## Application for Licence Amendment

<b>Licence Number</b>	L7340/1997/9
<b>Licence Holder</b>	Pilbara Iron Company (Services) Pty Ltd
<b>ACN</b>	107 210 248
<b>File Number</b>	DER2013/000903-2
<b>Premises</b>	<p>Yandicoogina Iron Ore Mine</p> <p>Part of Mining Lease AM70/274; LGE L021123</p> <p>NEWMAN WA 6753</p> <p>As defined by the coordinates in Schedule 2 of the Revised Licence</p> <p>As defined by the Premises maps attached to the Revised Licence</p>
<b>Date of Report</b>	11 June 2025 (FINAL)
<b>Proposed Decision</b>	Intent to grant revised licence

## Appendix 1: Summary of Banjima Native Title Aboriginal Corporation RNTBC comments on risk assessment and draft conditions

## Appendix 2: Summary of Licence Holder's comments on risk assessment and draft conditions

Figure 3: Distance to sensitive receptors

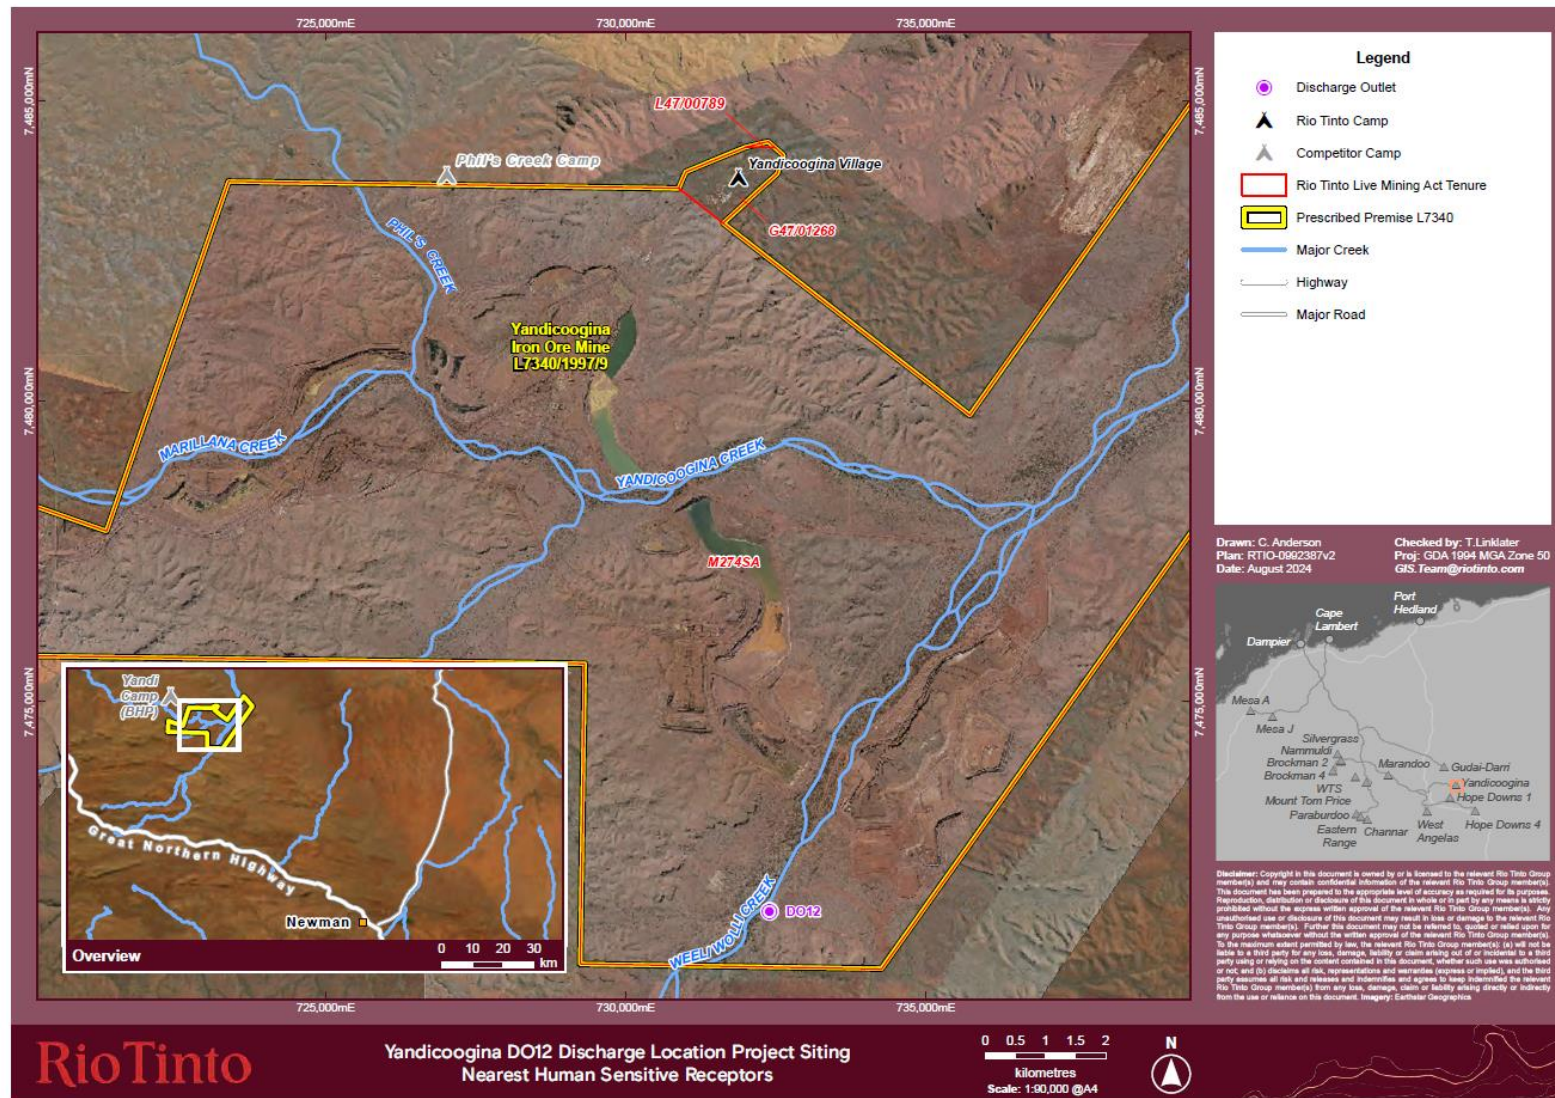
Figure 3	<p>DWER requested that the Licence Holder provide a map depicting distances to sensitive receptors.</p> <p>RTIO - A map showing human, flora and fauna sensitive receptors has been attached.</p>	Updated as requested.
